NORTH STAR TO NSW/QLD BORDER (NS2B)
INLAND RAIL PROJECT

DESKTOP STUDY ON FLOODING & GROUNDWATER
FINAL VERSION

STEPHEN N WEBB & ASSOCIATES PTY LTD

Figure 1: Landholders

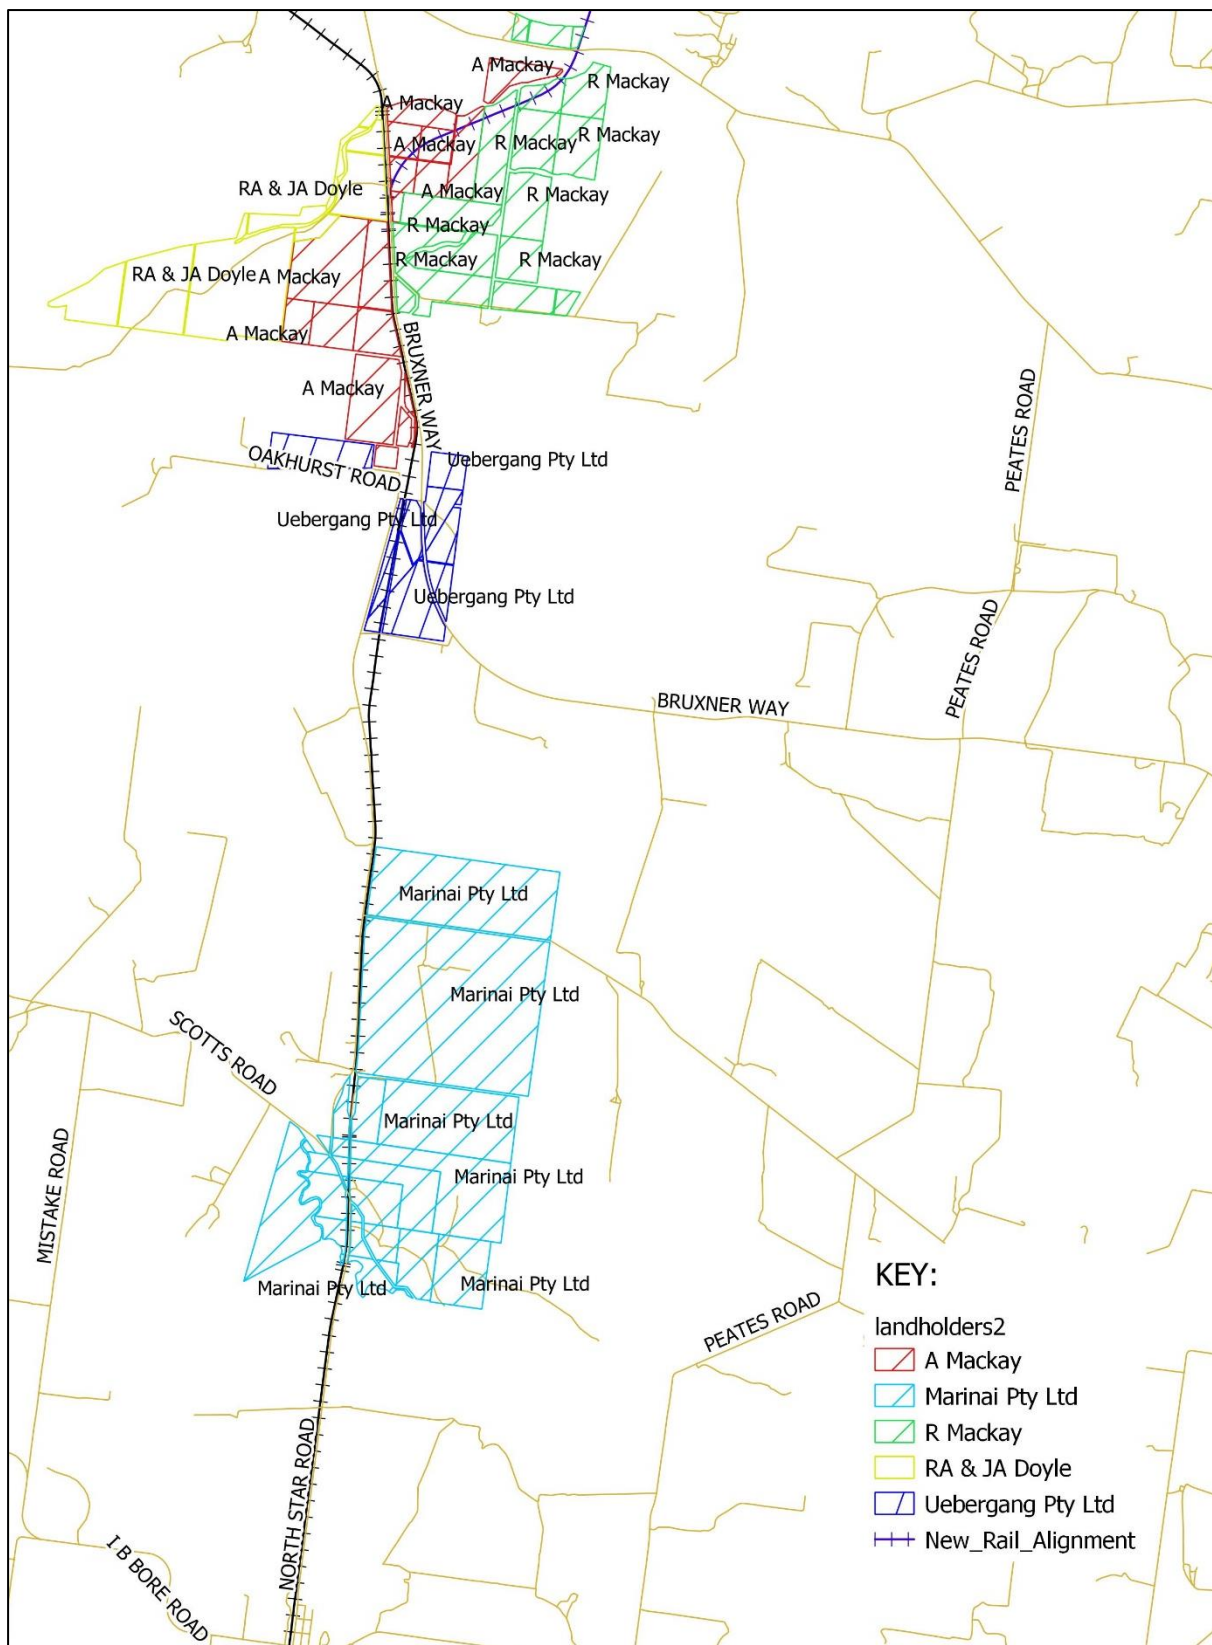
- It is important that the Drainage Structures in that section of the NS2B adjoining the Landholders (see **Figure 1**) be considered as a whole, and fully incorporated in the hydraulic model to have their impact assessed and sizing designed. Precise Drainage Structure locations could then be refined at the Detailed Design Stage in consultation with affected landholders.

Figure 2: Modelled Afflux – 1976 Flood Event

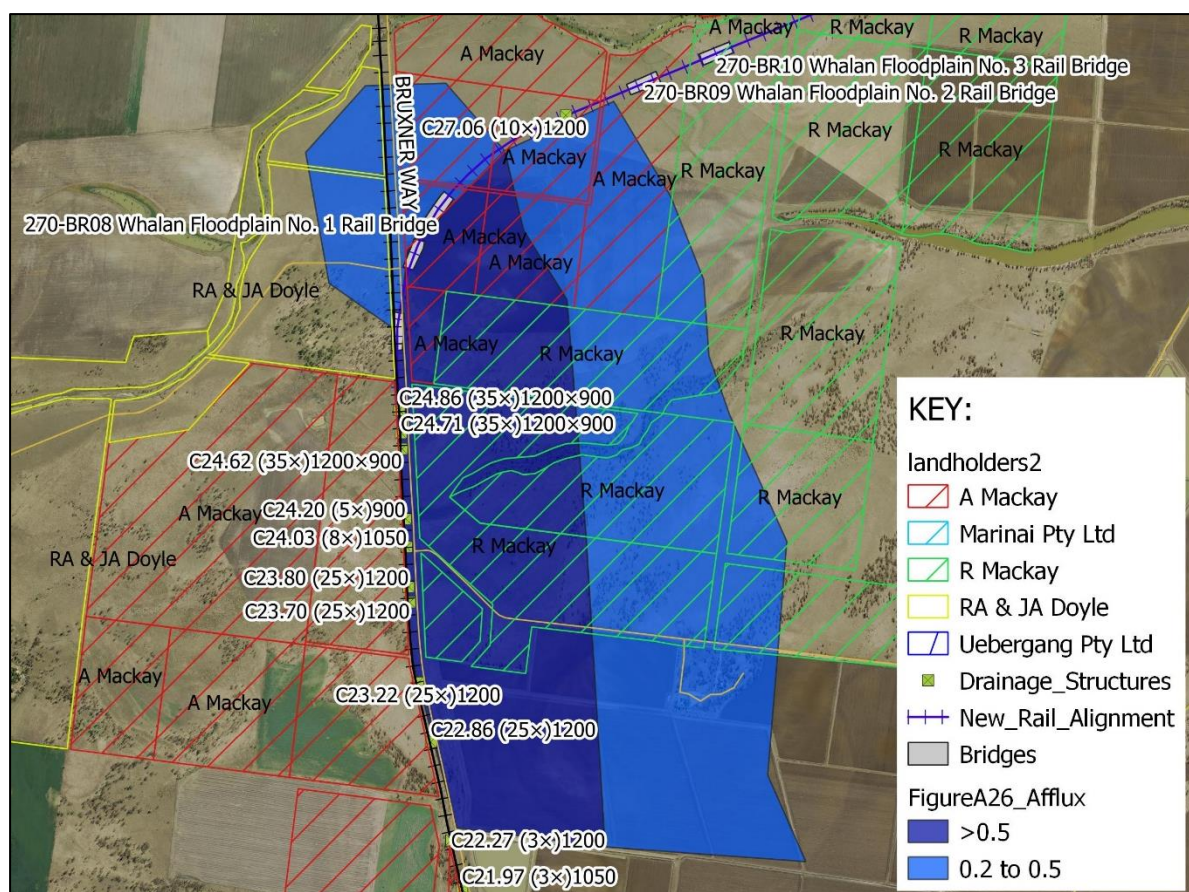
The afflux levels and drainage structures shown in **Figure 2** were sourced from Figure A26 of FFJV’s Report. **Figure 2** shows that A Mackay, R Mackay and RA & JA Doyle are impacted by an afflux greater than 200 mm and A Mackay and R Mackay are impacted by an afflux

greater than 500 mm. This amount of afflux is **significant** in BMT's opinion. It is **unacceptable** under the BRVFMP and is **unacceptable** to the Landholders.

The BRVFMP, ARR2019 and the Landholders Concerns all uphold that the affluxes modelled by FFJV for the 1976 flood are unacceptable. Prior to the approval of the NS2B EIS the impacts as outlined by the Landholders should be used to inform the design to reduce the afflux to acceptable levels for the 1976 flood event.
